PLANNING COMMISSION
DATE: 8/24/15
AGENDA ITEM: 5B – BUSINESS ITEM
CASE # 2015-28

ITEM: Savona 3rd Addition Residential Subdivision – Final Plat
SUBMITTED BY: Kyle Klatt, Planning Director *KL*
REVIEWED BY: Jack Griffin, City Engineer

Latest Revision Date: 08/06/15
Date: 02/27/15 Sheet: 6 OF 12

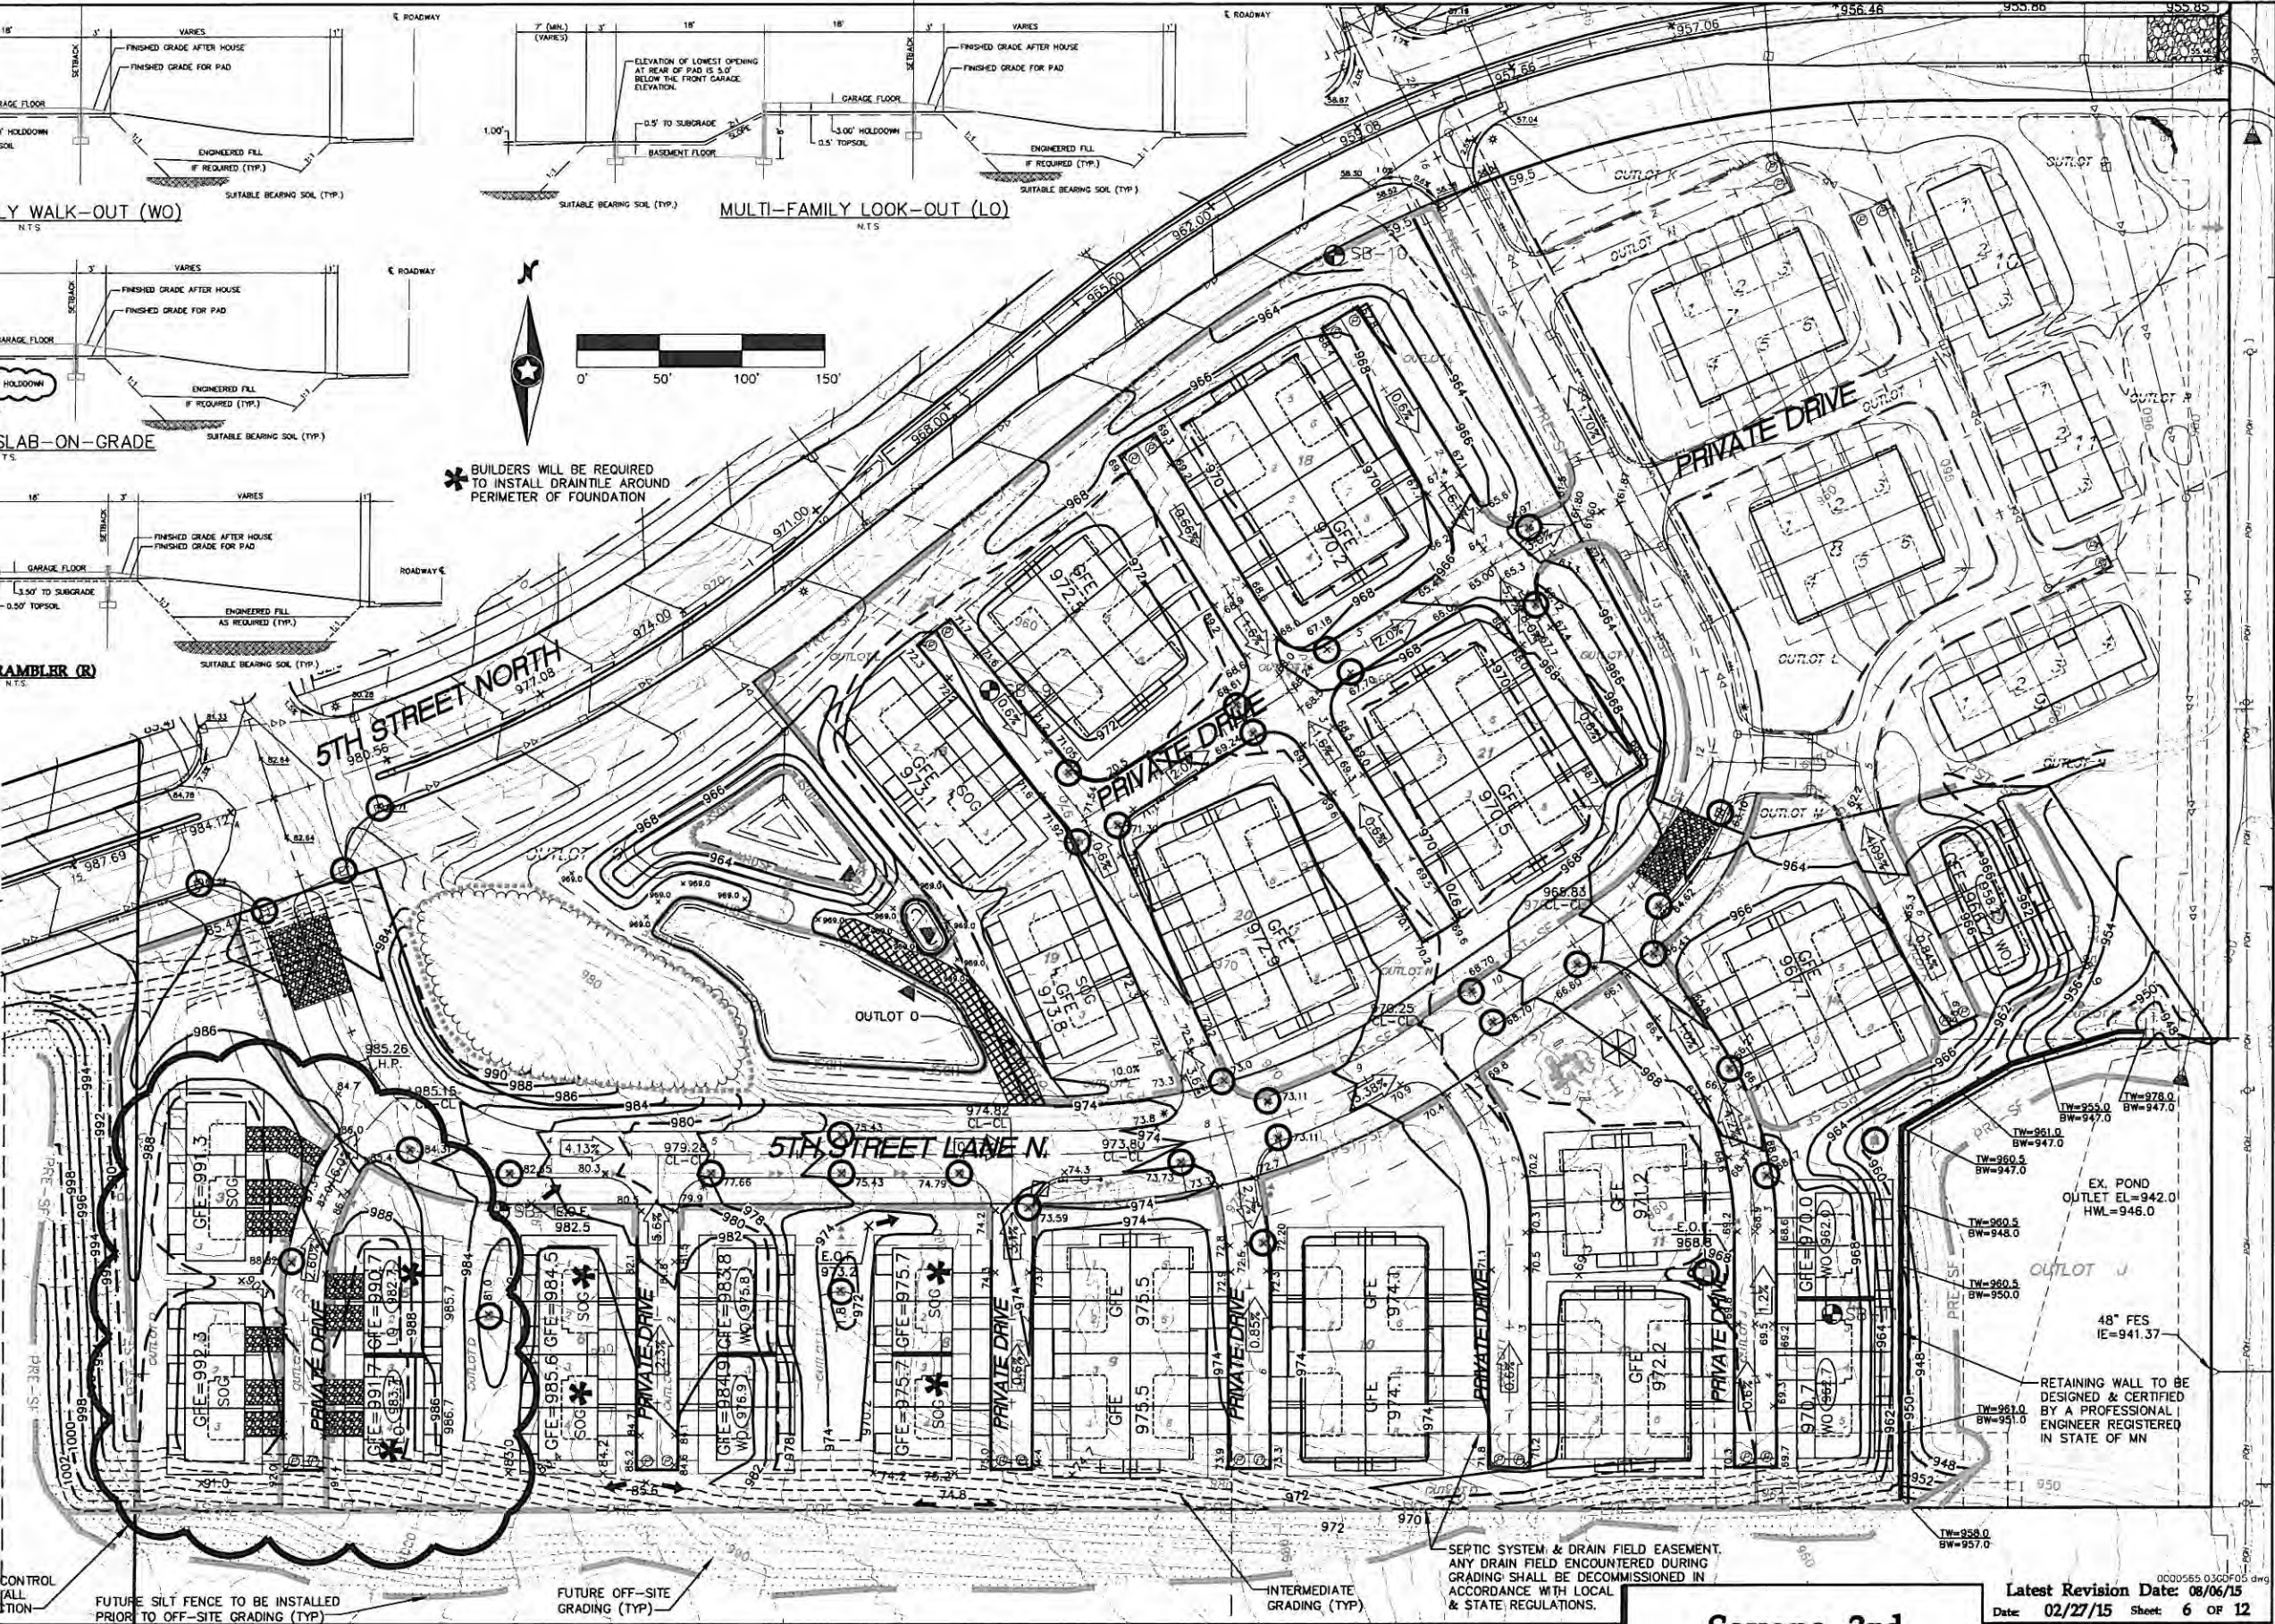
- **Townhouse Area Retaining Wall.** The revised grading and storm water plan for Outlot J in the southeast portion of the townhouse area now depicts a 10-12 foot retaining wall that will separate the storm water pond from the back of the planned townhouses. This wall must be designed in accordance with engineering standards and will need to comply with any applicable building codes concerning setbacks and public safety measures. Although the retaining wall is not a preferred option for grading in this area, the developer is requesting the proposed wall in order to accommodate the expanded pond without substantial revisions to the layout of the townhouses.

Date: 04/27/15 Sheet: 9 OF 21

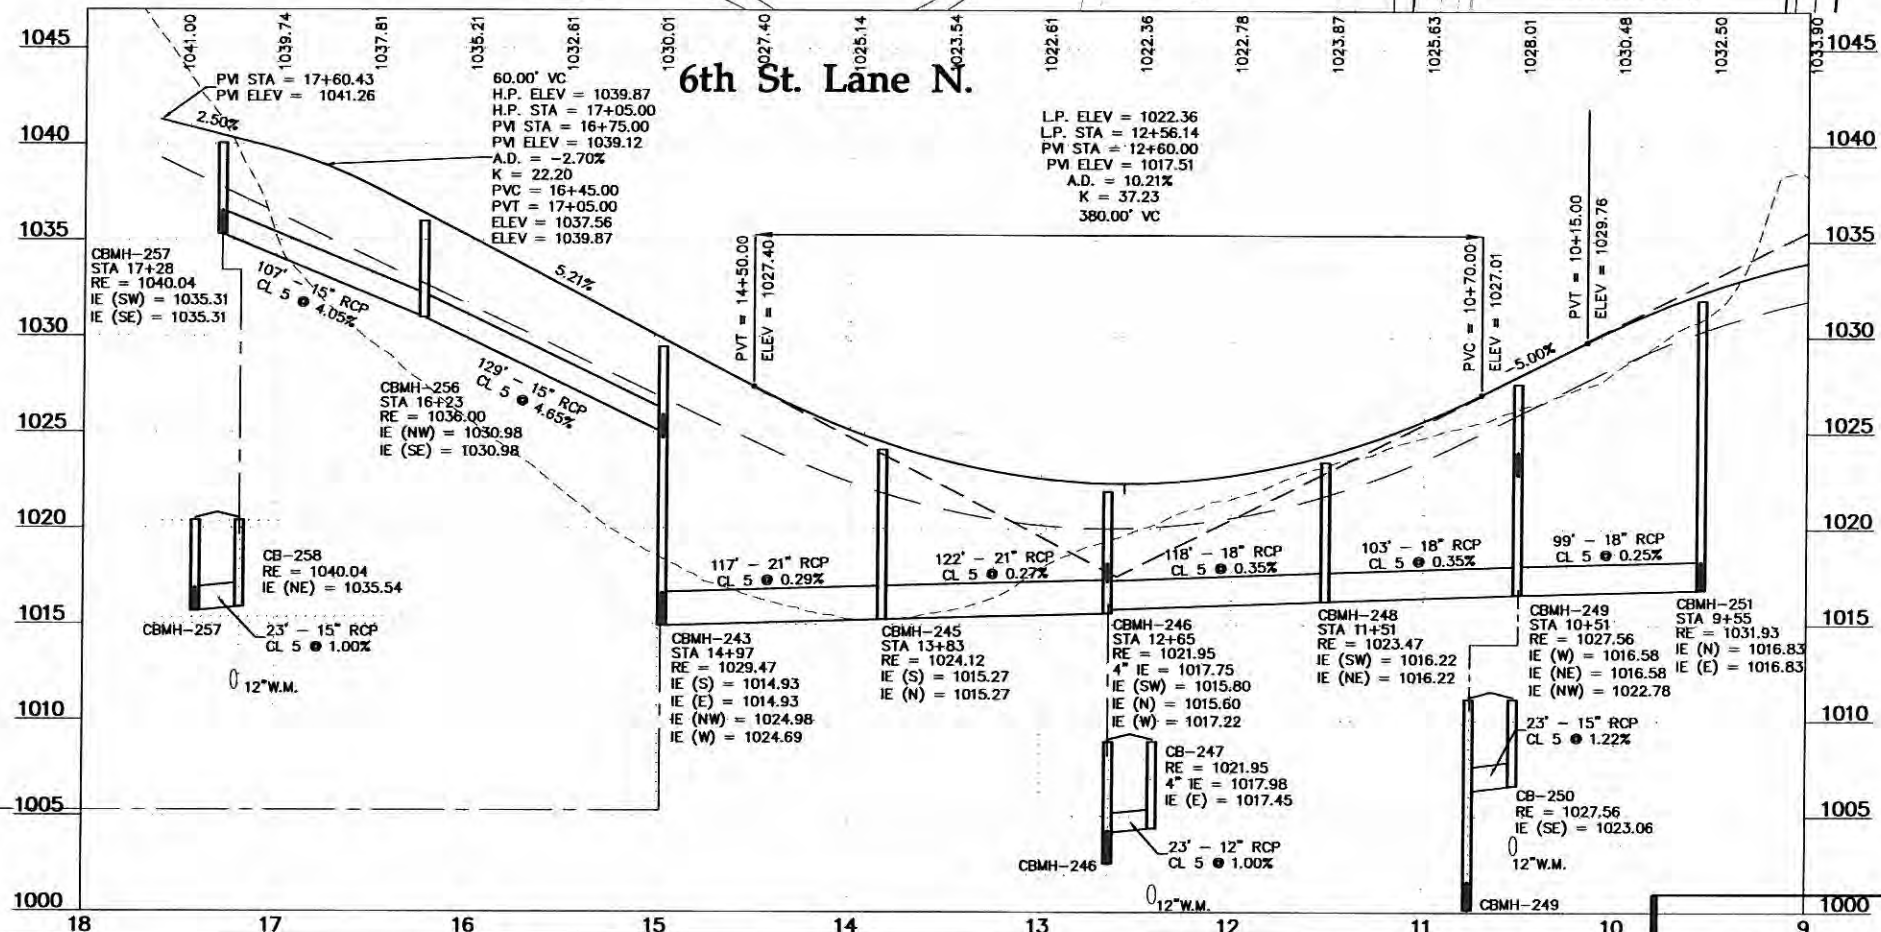
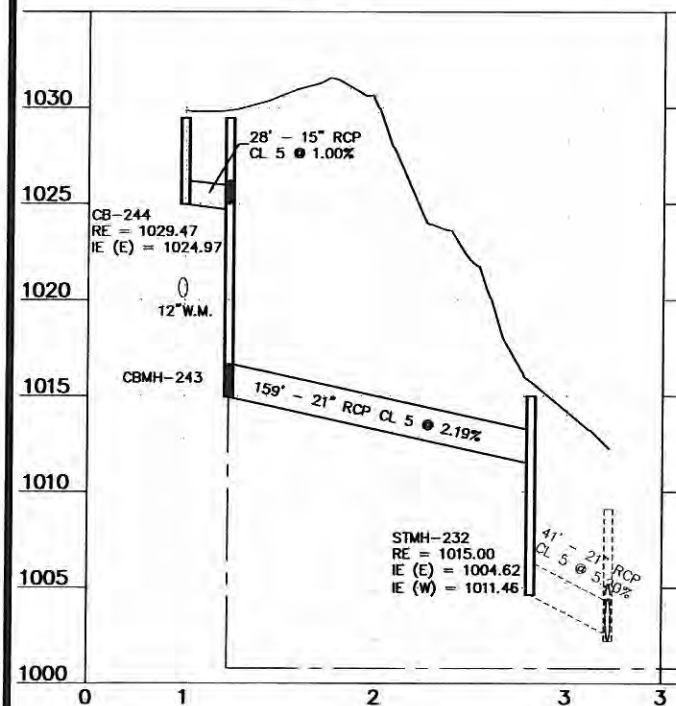
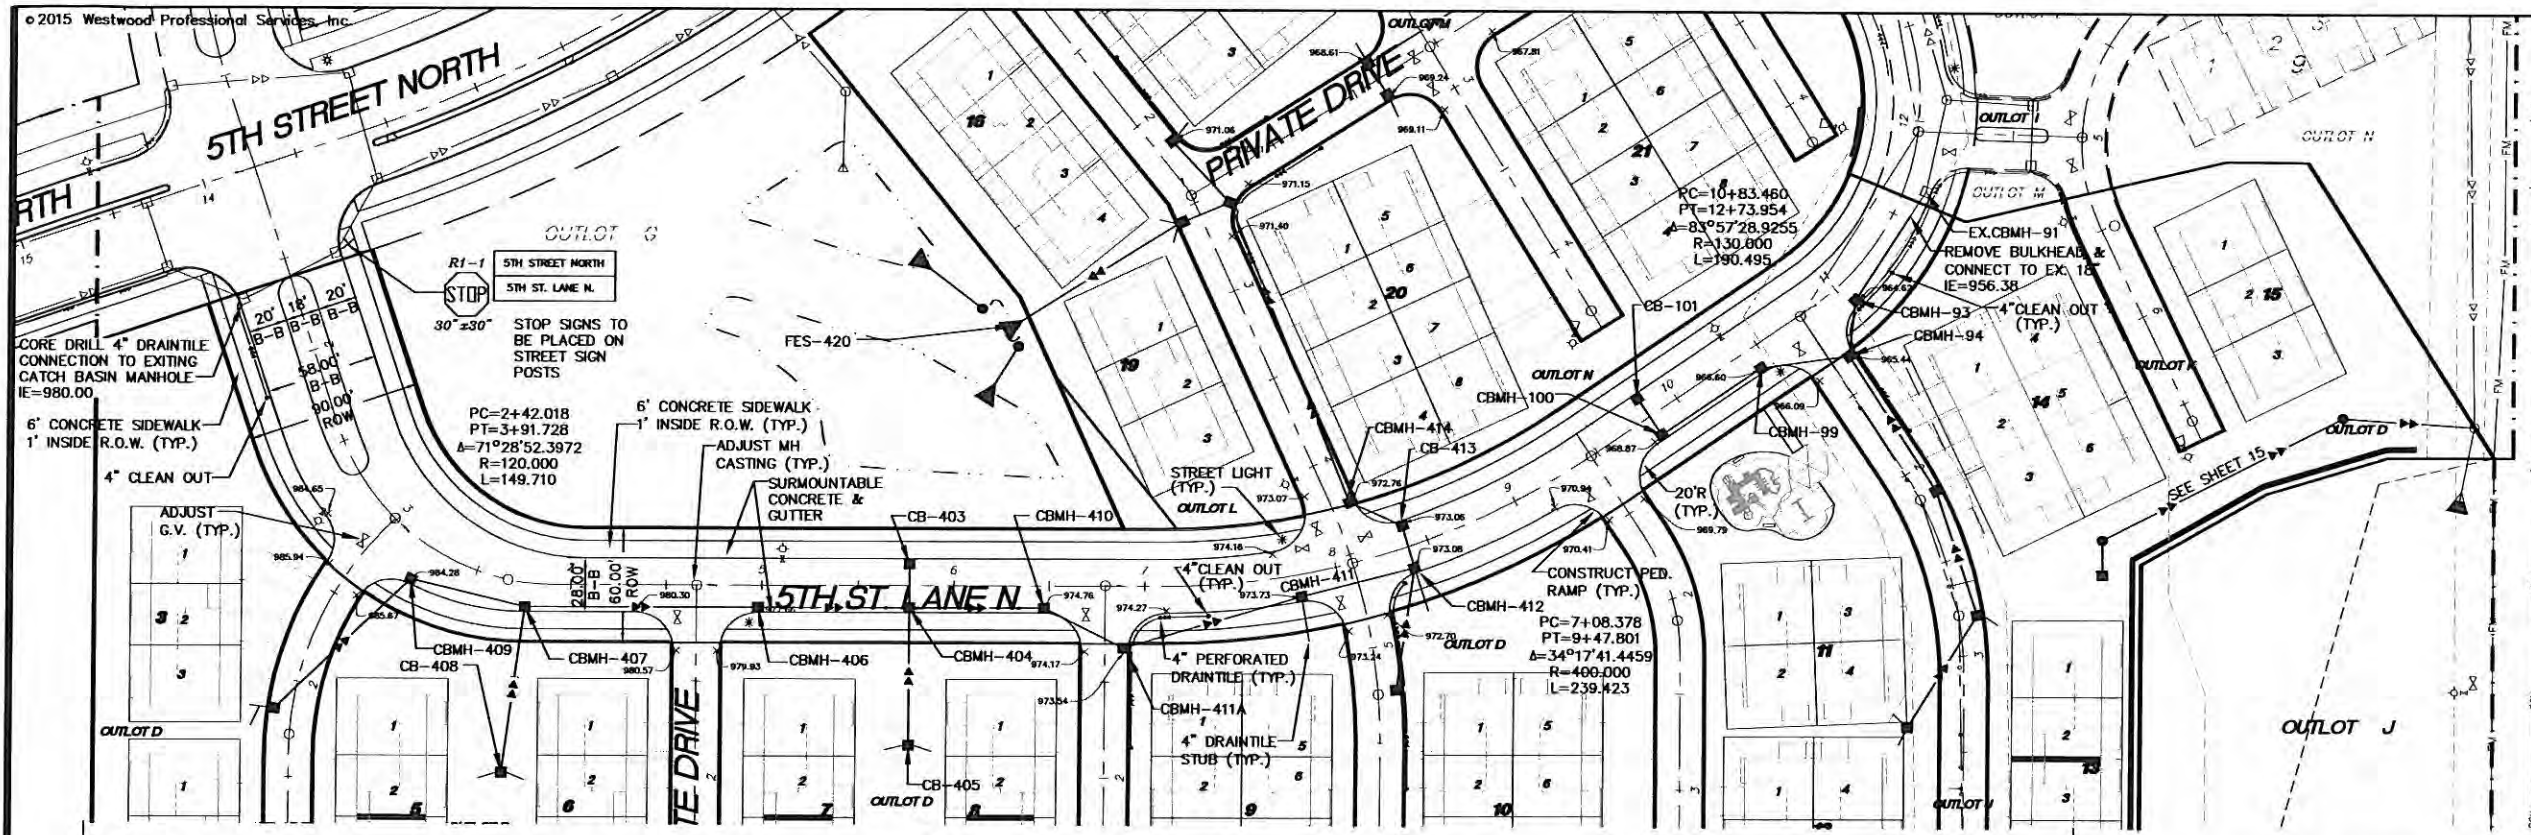
- Sheet 9 – CB-247 must be revised to allow the draitile invert to be above the top of effluent pipe.
- Sheet No. 9 – Remove "CB-250" text on Lot 3, Block 2.
- Sheet No. 10 – CB-405, CB-408, CBMH-94, CBMH-411A, CBMH-411 and CBMH-412 must be revised to allow the draitile invert to be above the top of effluent pipe.
- Sheet No. 10 – Add draitile at the low point on the southeast corner of the 5th Street Lane and 5th Street intersection.
- Sheet No. 15 – Storm sewer along Profile D must be a minimum of 15 feet from the backside of the proposed retaining wall and must be a minimum 15 inches in diameter.
- An updated Rational Storm Sewer Design Tabulation must be provided to include all storm sewer structures in Savona 3rd Addition.

Date: 04/27/15 Sheet: 10 OF 21

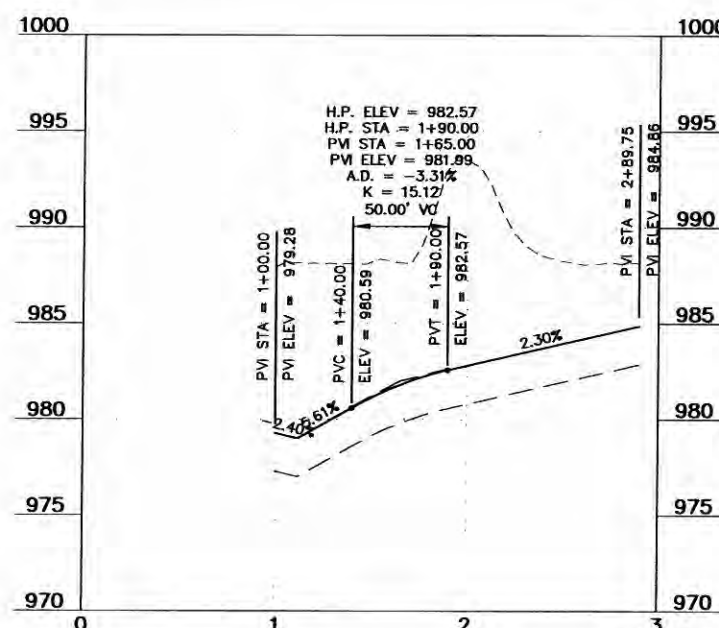
- Sheet No. 10 – Revise the Typical Section for 5th Street Lane (with Landscaped Median) to have an asphalt grade B and Traffic Level 2 (consistent with the remaining 5th Street Lane bituminous mix design).
- Sheet No. 11 – Private Drive 14 and 15 cannot have a breakover (rollover) angle in excess of 5%. This means the maximum difference between the slope of 5th Street Lane and the slope of the private drive cannot exceed 5%.
- Sheet 19 – Type III Barricades should remain on 5th Street at Junco Road.
- Sheet 19 – A paved turnaround must be accommodated at STA 29+70 on 5th Street.
- Sheet 20 – Signage for the left turn land must be added to the plan.
